UNITED STATES DEPARTMENT OF COMMERCE  
Patent and Trademark Office

07/655,514 03/06/90 TOMITA

## Part of Rejection: Drawing

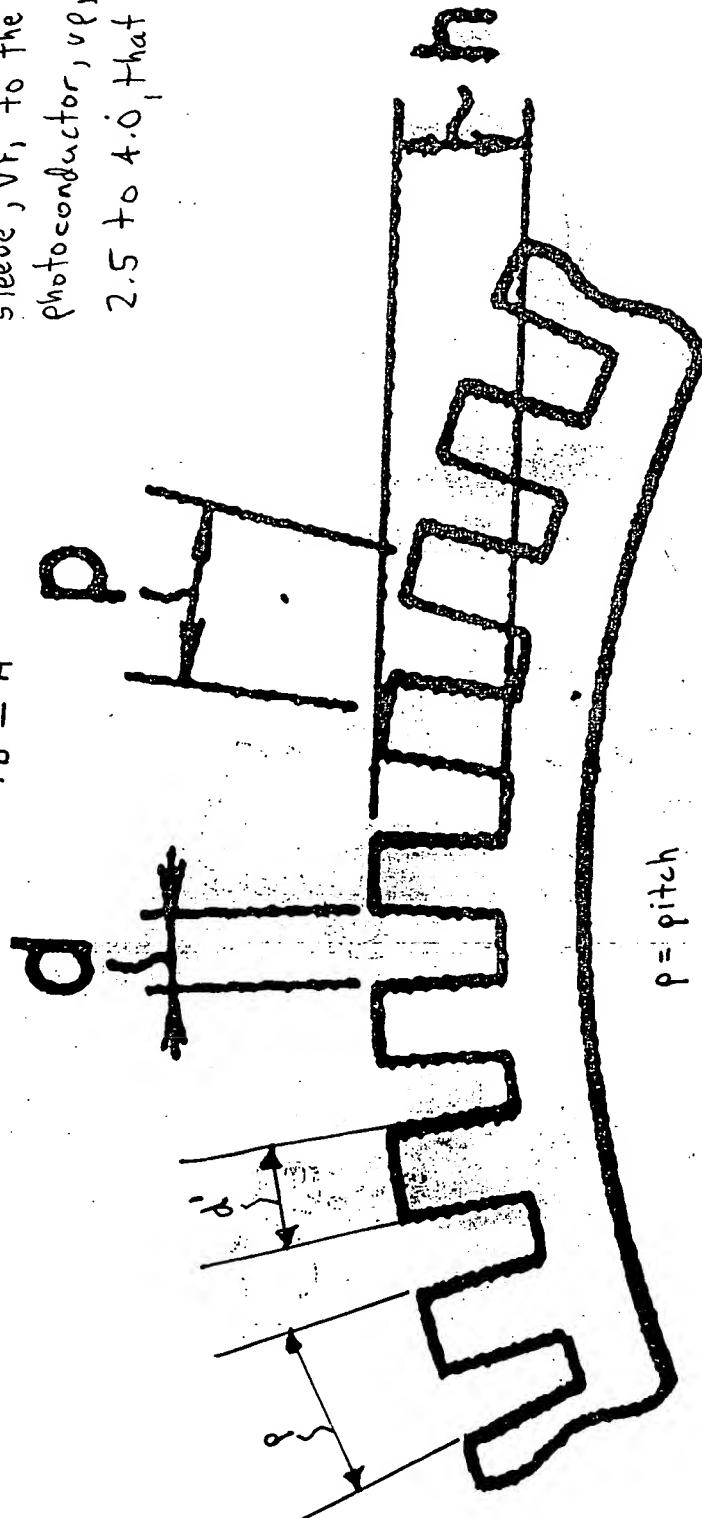
(1) Pitch of ridges,  $p$ , is defined as the distance from the center of one ridge to the center of the adjacent ridge, is in range from 1mm to 20mm.

(2) The width,  $d$ , of each groove between the ridges is in the range not less than  $1/10$  the pitch of the ridges,  $p$ , preferably in the range from  $1/10$  to  $1/2$  the pitch of the ridges,  $p$ .

$$d' = p - d \text{ and } d' = (1/10 \text{ to } 1/2)p$$

$$\therefore (p - 1/2p) \times V_r / V_p \geq p$$

which essentially satisfied  $C \times S/D \geq A$

(3) Conventionally, in order to prevent the decrease of development performance ..., it is required that the ratio of the peripheral speed of the non-magnetic sleeve,  $V_r$ , to the peripheral speed of the photoconductor,  $V_p$ , be approximately 2.5 to 4.0, that is  $V_r/V_p \approx 2.5$  to 4.0.
